APPLICATION NO.	FILING DATE	FIRST NAMED INVENTOR	ATTORNEY DOCKET NO.	CONFIRMATION NO.
10/727,509	12/05/2003	Claude Dube	87367.1800	7856

Office Action Summary	Application No. 10/727,509	Applicant(s) DUBE ET AL.	
	Examiner Noah C. Hawk	Art Unit 3637

DETAILED ACTION***Drawings***

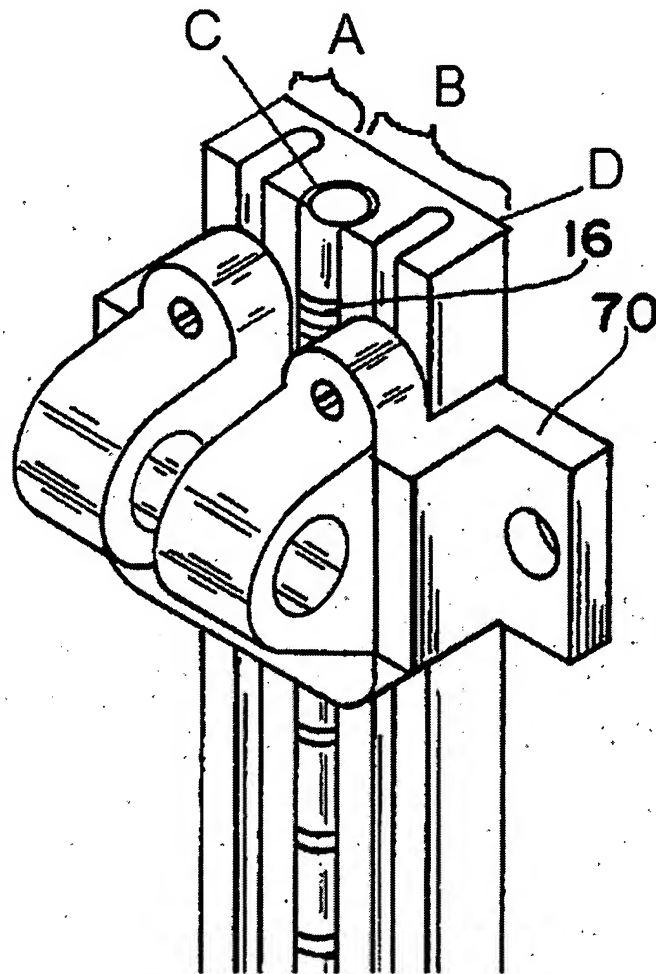
7. Claim 1, 2, 9, 10, 12, 14-16, and 18 are rejected under 35 U.S.C. 102(b) as being anticipated by Lakso in US Patent 4854653.

Lakso, Figure 1 (detail)

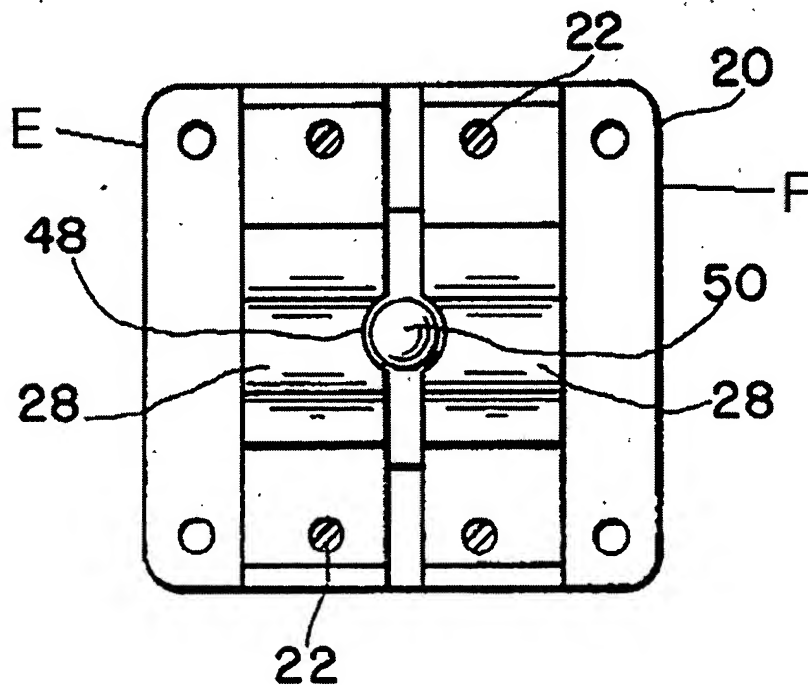
a. Regarding Claim 1, Lakso teaches an interlocking system for preventing simultaneous opening of drawers of a cabinet, comprising activation members (60) respectively affixable to back sides of the drawers; guide supports (20) respectively affixable in the cabinet behind the drawers, in respective registration with the activation members; an elongated track member (groove C, best seen in Lakso, Figure 1 detail, below) affixable in the cabinet on a side of the guide supports; a series of mobile blocks (14) slidably guided by the track member, the track member limiting the blocks to a partial displacement to produce a space between any two of the blocks; carriage members (30) respectively mounted on the guide supports, the carriage members being movable transversely to the track member, the carriage members respectively having bolt elements (50) projecting towards the track member and drivable one at a time in the space produced by the partial displacement of the blocks by sliding of the carriage members towards the track member; and coupling means (the

combination of 36, 40 and 64) respectively extending between the activation members and the carriage members for sliding one of the carriage members towards the track member using pulling motion of a corresponding one of the activation members during opening of a corresponding one of the drawers (the edge 44 of the carriage member moves toward the track member during the opening of a drawer), provided that the space is vacant for receiving the bolt element of said one of the carriage members, and sliding said one of the carriage members away from the track member using pushing motion of said one of the activation members during closing of said corresponding one of the drawers.

b. Regarding Claim 2, Lakso further discloses that the coupling means (the combination of 36, 40 and 64) comprise guiding groove (the "apertural leaf" 64) and pin arrangements (pins 36 and 40) distributed between the activation members and the carriage members.

c. Regarding Claim 9, Lakso discloses that the device further comprises a mounting structure (12) having opposite first (A, best seen in

Lakso, Figure 1 detail) and second (B, best seen in Lakso, Figure 1 detail) mounting rails affixable in the cabinet behind the drawers and between which the guide supports are mountable (see Lakso, Column 2, lines 27-29), second mounting rail (B) providing a support structure for the track member (C).
